Project	<b>IEEE 802.16 Broadband Wireless Access Working Group</b> < <a href="http://ieee802.org/16">http://ieee802.org/16</a> >	
Title	<b>Comment on Unsolicited RNG-RSP in transparent RS System</b>	
Date Submitted	<b>2007-07-18</b>	
Source(s)	Kanchei (Ken) Loa, Yi-Hsueh Tsai, Yung-Ting Lee, Hua-Chiang Yin, Shiann-Tsong Sheu, Youn-Tai Lee,  Institute for Information Industry 8F, No. 218, Sec. 2, Dunhua S. Rd., Taipei City 106, Taiwan	Voice: +886-2-27399616 Fax: +886-2-23782328 loa@iii.org.tw
Re:	IEEE 802.16j-07/019: "Call for Technical Comments Regarding IEEE Project 802.16j"	
Abstract	This contribution proposes the modified figures of MS unsolicited RNG-RSP in non-transparent RS system under centralized scheduling scheme based on comment #1141 of 80216j-07_014r4.cmt.	
Purpose	Text proposal for 802.16j Baseline Document.	
Notice	<i>This document does not represent the agreed views of the IEEE 802.16 Working Group or any of its subgroups. It represents only the views of the participants listed in the "Source(s)" field above. It is offered as a basis for discussion. It is not binding on the contributor(s), who reserve(s) the right to add, amend or withdraw material contained herein.<

Figure 108f—Unsolicited RNG-RSP ~~in Transparent RS system~~ triggered by upstream traffic at Transparent Access RS

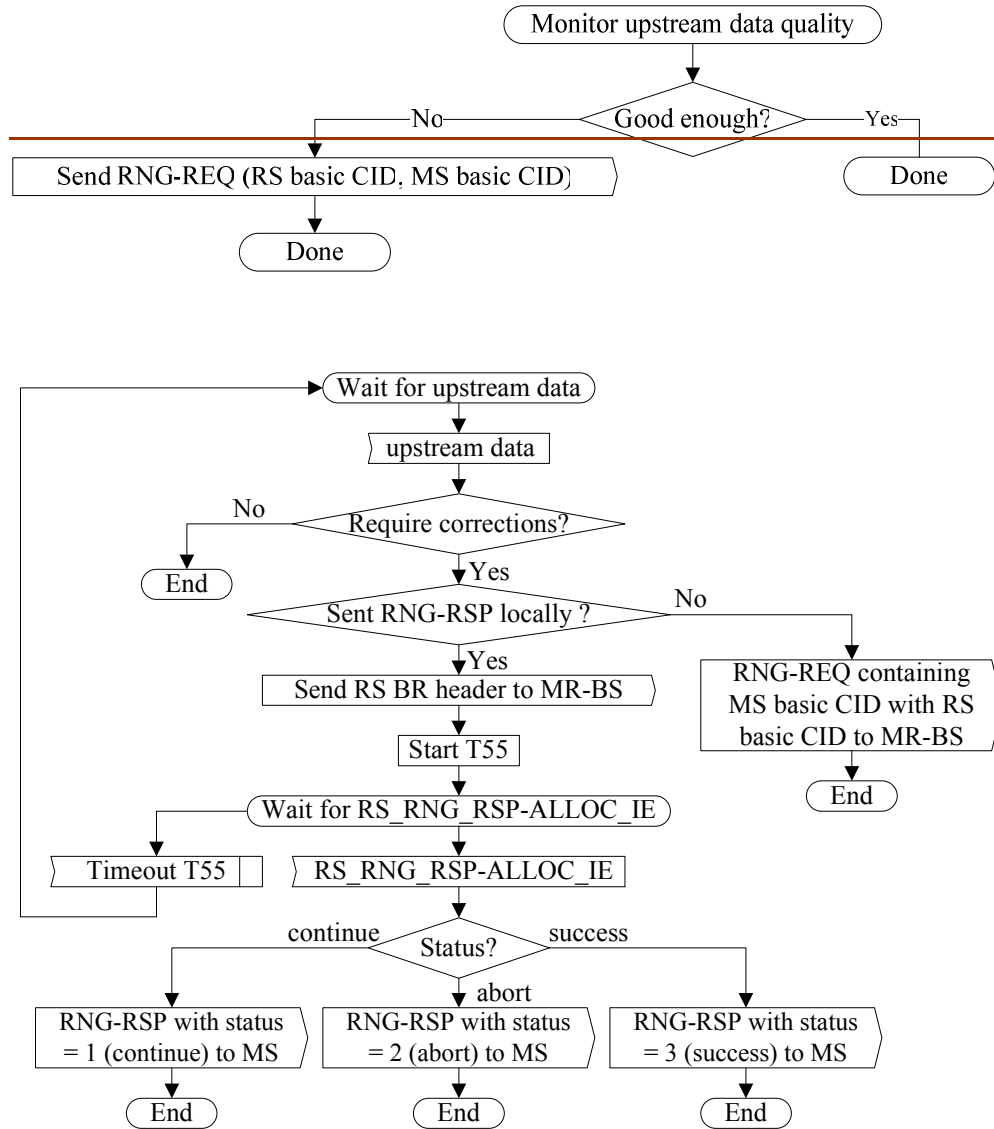
[Replace the following Figure 108g in page 99 as indicated]

Figure 108g ~~Unsolicited RNG-RSP in Transparent RS system~~ Handle RNG-REQ in transparent mode at MR-BS

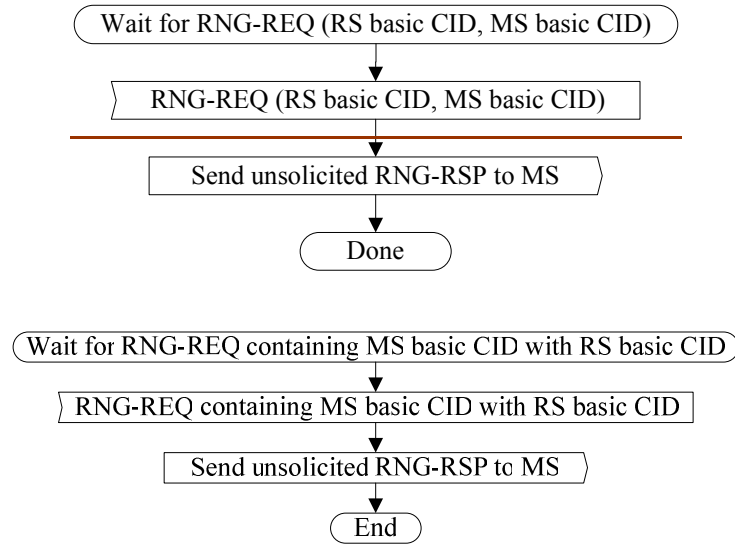
[Replace the following Figure 108h in page 99 as indicated]

Figure 108h ~~Unsolicited RNG-RSP triggered by CDMA BR ranging code in Transparent RS system at~~ Transparent Access RS

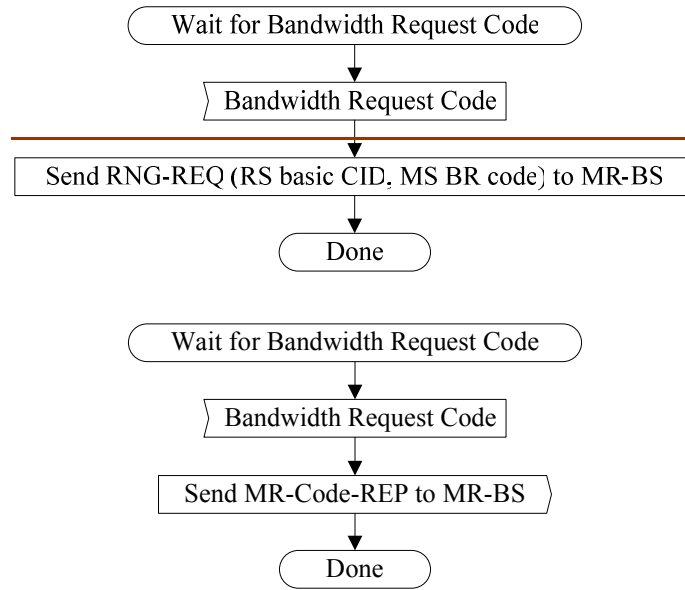
[Replace the following Figure 108i in page 99 as indicated]

Figure 108i Unsolicited RNG-RSP triggered by CDMA BR ranging code in Transparent-RS system mode at MR-BS

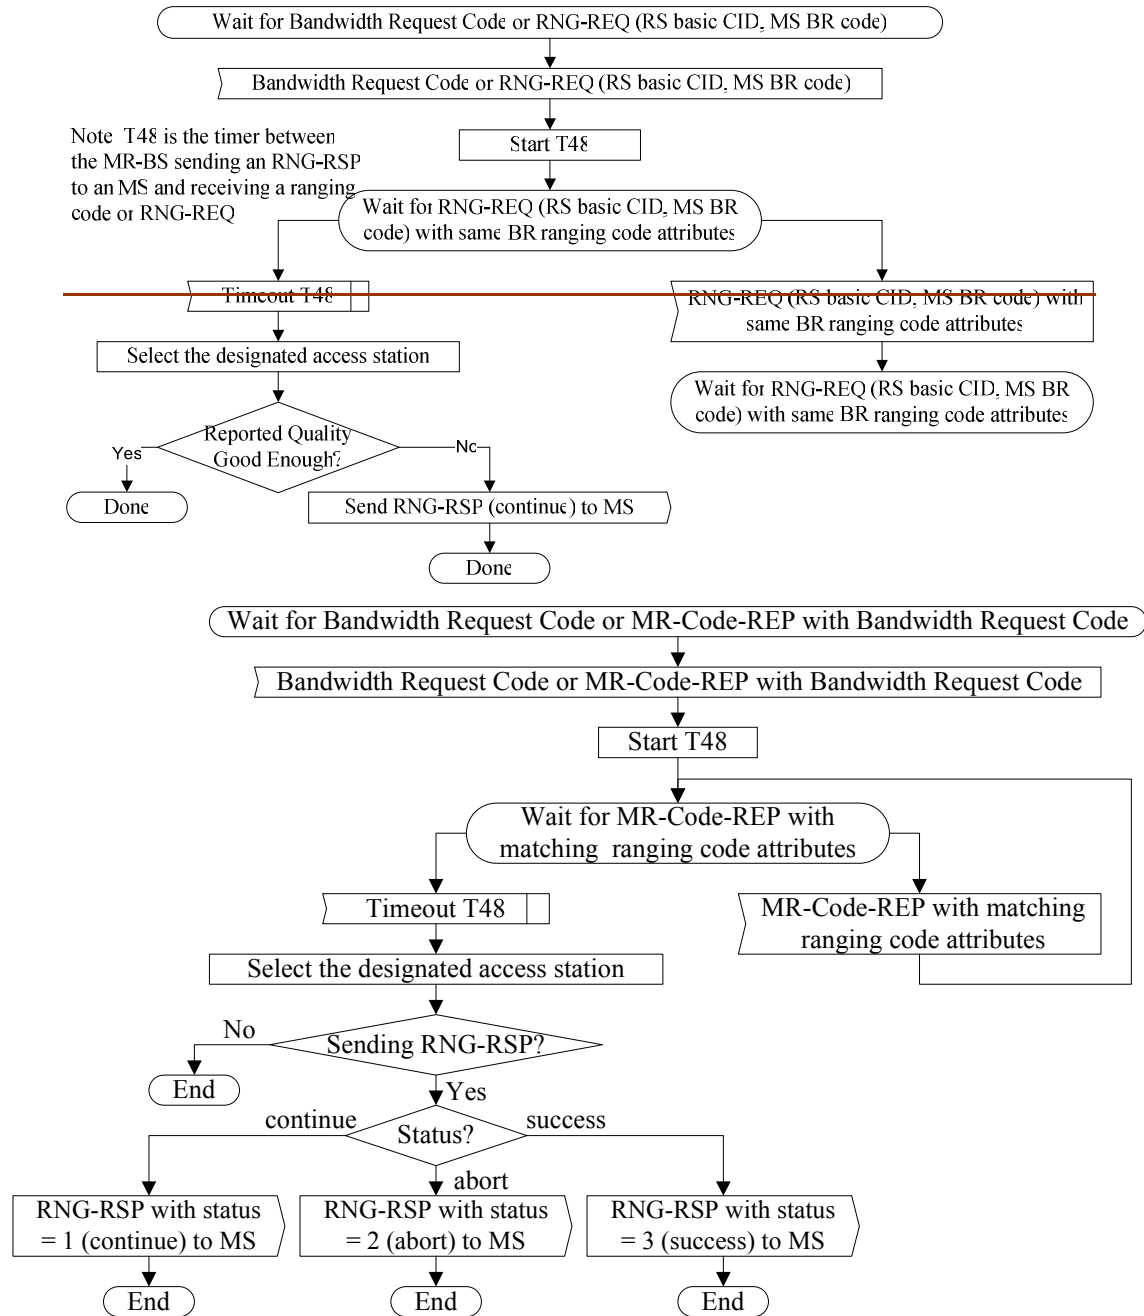
The message sequence charts (Table ~~xxx201d~~ and Table ~~yyy201e~~) and flow charts (Figure 108f, Figure 108g, Figure ~~xxx108h~~ and Figure ~~yyy108i~~) define the unsolicited RNG-RSP process that shall be followed by compliant RSs and MR-BSs.
